# NOTICE OF DECISION

## PLANNING ADMINISTRATOR DECISION FOR SITE PLAN REVIEW

**CASE TYPE:** Class 2 Site Plan Review  
**AMANDA NO.:** 22-21631-PLN  
**DATE OF DECISION:** January 3, 2023  
**PROPERTY LOCATION:** 725 Shipping Street NE  
**APPLICANT:** Kathryn Casey, AC+CO  
**ZONE:** MU-II (Mixed Use-II)  
**COMPREHENSIVE PLAN:** MU (Mixed Use)  
**OVERLAY:** None

A Class 2 Site Plan Review for the conversion of an existing structure into a 12-unit Multiple Family Apartment building. The property is approximately 0.24 acres in size, in the MU-II (Mixed Use) zone and located at 725 Shipping Street NE (Marion County Assessor Map and Tax Lot 073W23BB/1700).

**1 SITE PLAN**  
SCALE: 1" = 10'-0"

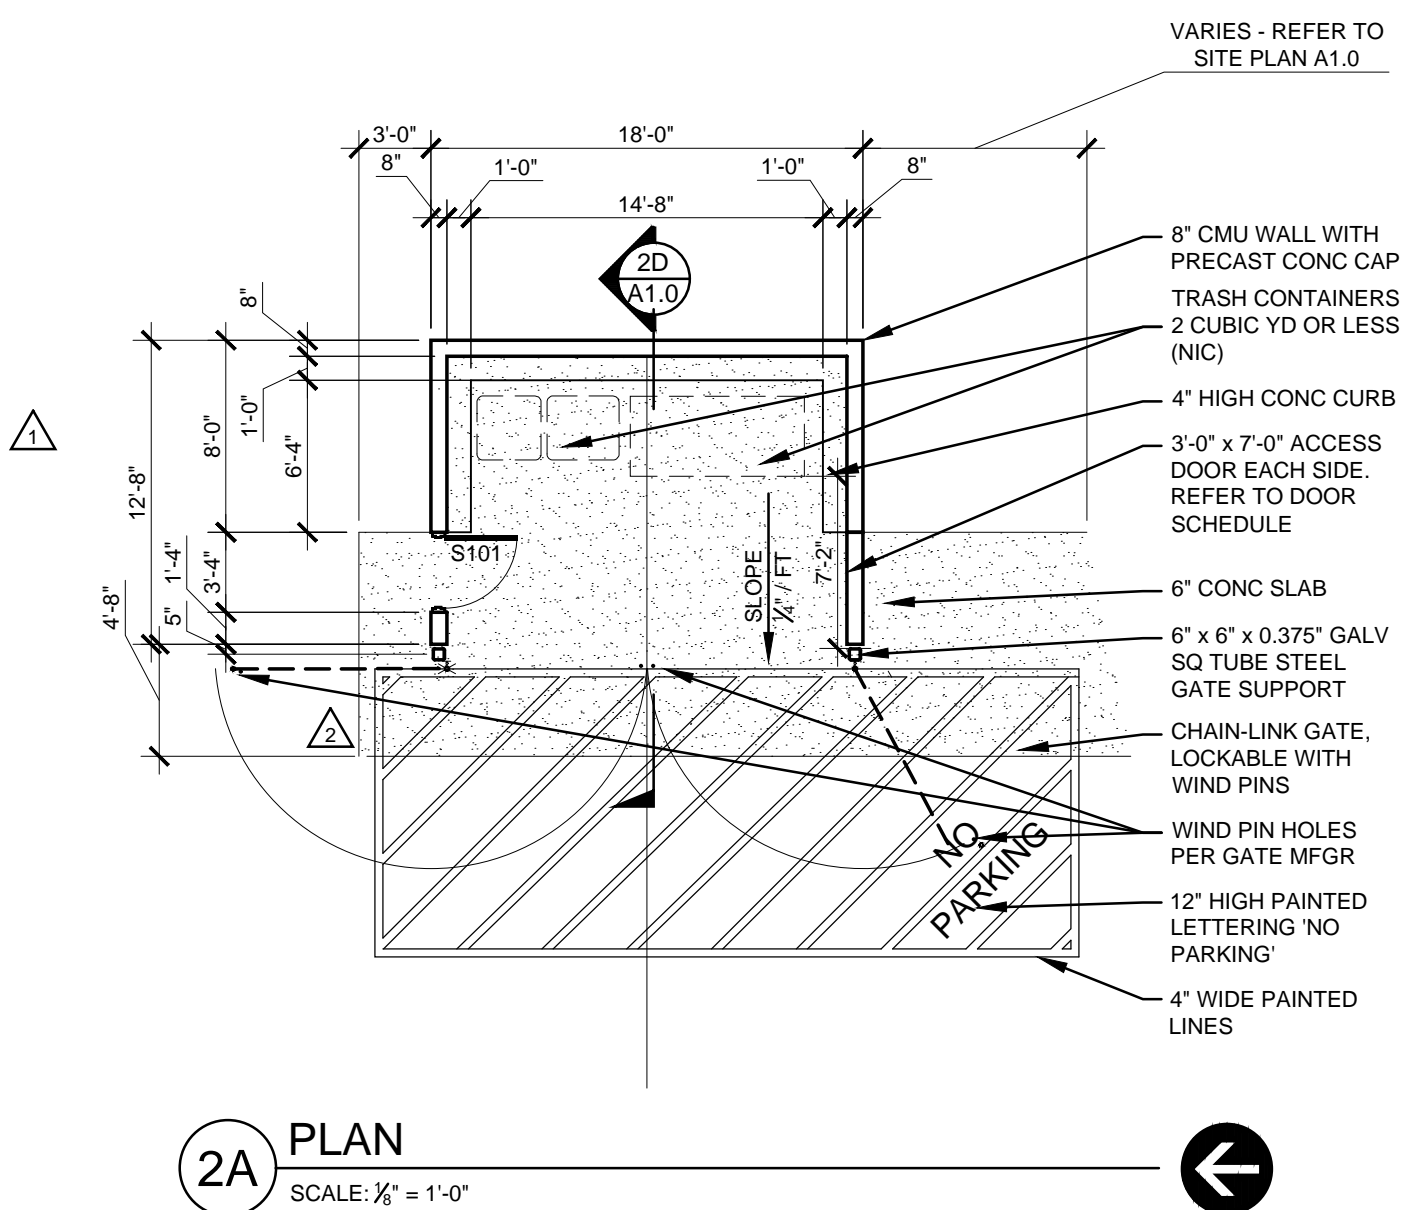
**Finding:** The proposal does not impede or alter setbacks of the existing structure. The new trash enclosure is located approximately ten feet away from the street setback. No new paved area encroaches into the setback area. Landscaped area meets compliance with all applicable standards; therefore, this standard is met.

**Finding:** The applicant's development plans indicate that the site will have approximately 31.6% landscaped area (3,312 sq. ft. Landscaped Area/10,454 square feet = 31.6%). The applicant is retrofitting previous off-street parking into landscaped area, which will include setback areas; therefore, the proposal meets these standards.

**Finding:** The site plan indicates that the base of the enclosure will be on a 6" thick concrete slab, consistent with applicable standards. The pad will extend a minimum of one foot beyond the sides and rear, and three feet beyond the front of the gate. The enclosure is sloped at 1/4" foot towards the gate to discharge stormwater runoff; therefore, this standard is met.

**Finding:** Adequate separation distance is provided within the enclosure. Receptacles will not be placed within five feet of a building or structure; therefore, this standard is met.

**Finding:** The site plan indicates an unobstructed vertical clearance above the enclosure, which meets the minimum 14 feet of vertical clearance requirement; therefore, this standard is met.

**Finding:** The subject property is located within a Mixed-Use zone, with neighboring properties being either the same or similar zoning designation. The proposed six and half foot tall enclosure will be constructed of structural concrete, which screens the solid waste service area from abutting properties and streets; therefore, this standard is met.

**Finding:** The width of the proposed front opening for the enclosure is approximately 18 feet, exceeding the minimum standard; therefore, this standard is met.

**Finding:** The applicant indicates on the site plan there will be a minimum four-inch-high bumper inside the perimeter of the proposed enclosure; therefore, this standard is met.

**Finding:** The proposed gates can swing to 90 degrees and have restrainers in the open and closed position; therefore, this standard is met.

**Finding:** The applicant shows a vehicle turnaround area that meets the minimum dimensional requirements SRC 806. Access to the enclosure will occur from Shipping Street NE, with a driveway width of approximately 15'-10" feet in width and 62' feet in length. Non-service vehicles will not be permitted to park in this area, ensuring it's free of obstructions; therefore, this standard is met.

**Finding:** The applicant shows a vehicle turnaround area adjacent to the eastern side of the existing structure. This turnaround area meets the dimensions of SRC 806, table 806-7; therefore, this standard is met.

**Finding:** The applicant shows that the enclosure will have "No Parking" painted on the pavement in front of the enclosure to ensure the area will remain unobstructed by vehicular traffic; therefore, this standard is met.

**Findings:** The applicant's site plan indicates twelve proposed bike parking spaces on the property. These are located approximately 37 feet away from a building entrance located on the eastern side of the existing structure; Therefore, this standard is met.

**Finding:** The proposed stalls are located directly parallel from the eastern entrance and located 37 feet from the primary entrance. There are no obstructions between this space that would either hinder or prevent continuous access between the existing structure and the bicycle stalls; therefore, this standard is met.

**Finding:** The site plan shows that the location of the bicycle parking will have clear and direct access to the right of way, via Shipping Street, which has existing and improved driveway, continuously free of obstructions; therefore, this standard is met.

**2** BIKE RACK PLAN DETAIL  
SCALE: NTS

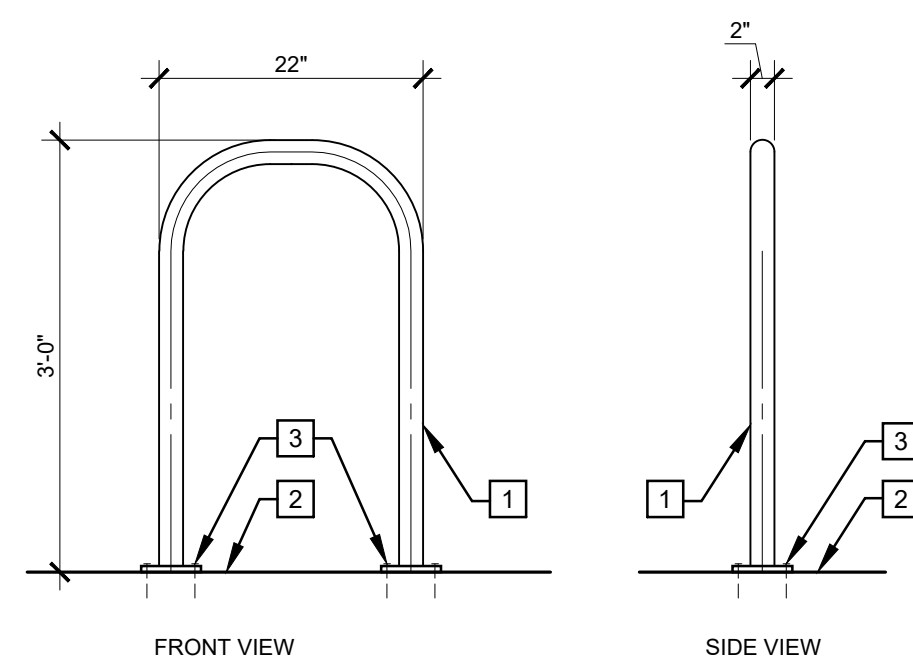
**Finding:** The applicant has indicated on the site plan that the proposed stalls are compliant with all applicable dimension requirements. Utilizing a staple/inverted rack, bikes will be supported in a stable position, in two or more places, without damaging either the wholes, frame, or other components; therefore, this standard is met.
